Response to Request for Review

Please find below the response to the request for review formulated for the CDM project with the registration number 1339. In case you have any further inquiries please let us know as we kindly assist you.

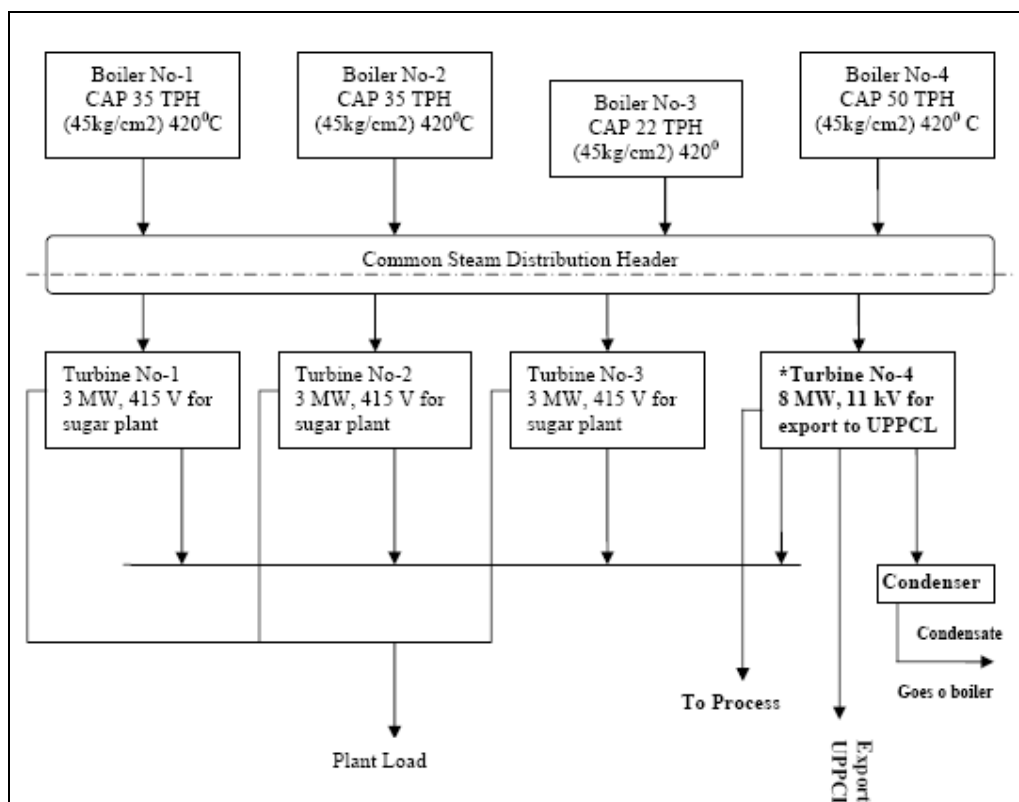
Further clarification is required on the timeline of the project activity and how the prior consideration of the CDM has been validated.

Prior consideration of CDM was validated as presented in section B.5.1 of the Annex 1 of the validation report. However, further clarification is provided as follows:

The decision to implement the project activity was taken on 11 May 2006 after considering the incentives from CDM. Resolution passed in the Project Committee Meeting of the Company held on 11 May 2006 was already submitted while requesting registration for the project activity. The document is again enclosed (Annexure-14). The implementation/real action of the project activity started subsequently on 13 May 2006 with signing of contract agreements for purchase of turbines. All the major steps in the process of implementation of the project were carried out later as follows:

- 13th May 2006 Contract agreement for purchase of turbines
- 14th July 2006 Contract agreement for purchase of boilers
- 17 May 2006 Power purchase agreement signed
- 03 July 2006 Loan sanctioned
- 27 September 2006 No objection from State Pollution Control Board to implement the project

The process to avail the CDM benefits was started in June 2006 with appointment of CDM consultants and subsequently the appointment of DOE in September 2006. The applied methodology (ACM0006) was already available since September 2005. Hence it is evident that incentives from CDM were seriously considered in decision to implement the project activity
